# Product Change Notification (PCN)

PCN Number	505462	Date Issued	September 07, 2018
Reason for Change	Change to Product		
Change Type Description	This letter is to inform you that changes are being made to the part(s) identified in this Notice. The change may affect the fit, form, function or appearance of the parts, or it may result in a change to the specification. The pictures below show an example of the possible differences.		
Reason for Short Notice	Corrective Actions		
Assessment of Change	First article inspection		
Internal Molex Qualification Date	April 10, 2018		
Sample Availability Date (Changed Part)	April 10, 2018		
Planned Implementation Date	September 30, 2018		
Method of Identifying Change	Date code

## Before Change

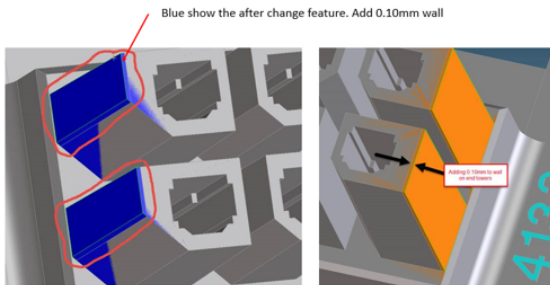
- Add 0.10mm wall

- To reduce the risks of receptacle housing is not guided into full alignment during mating process due to dimensional sizing of parts and/or angle mating and it will cause receptacle housing tower end have stubbing issue when mating.
- Product Impact
  - There is dimension change to the product as the picture.
- Part Number Impact
  - This change will impact to 44133-XX00, 12CKT-24CKT
- Qualification Reports and samples available upon request after the date shown above
